Gasper Flores Survey No 412

N. de la Jexda Sur No 412

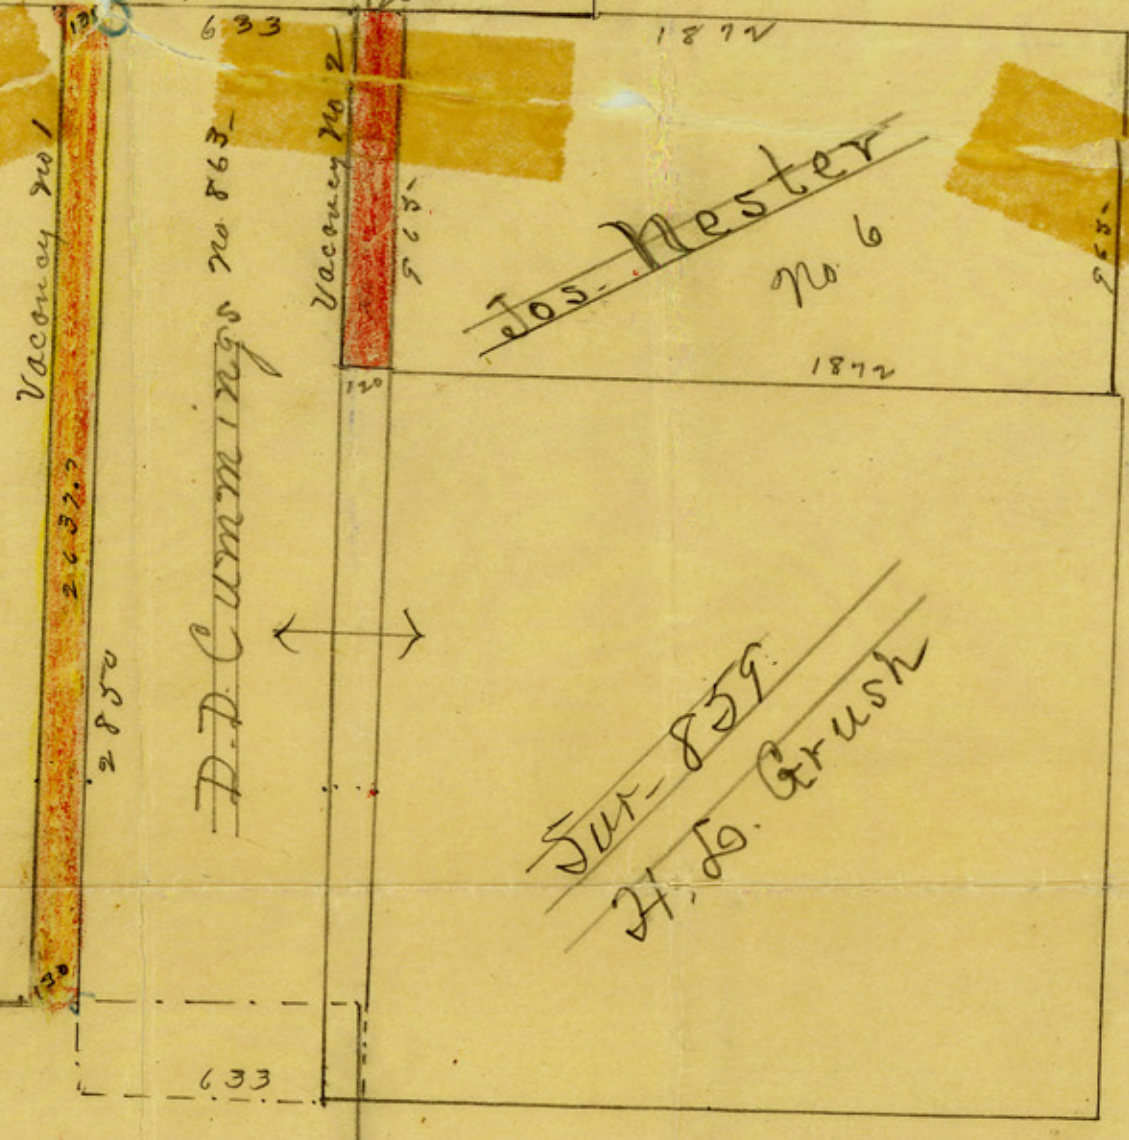
E 5170 varies to N.E. cor. of this survey - no. 412  
Proved to be 5300 varies to well identified cor. marked with  
blue circle. This excess may be caused by the  
present line not crossing creek exactly where it did  
originally - J.M. Stubbs, contractor of diwaldes

Both trees are  
standing -  
J.M. Stubbs
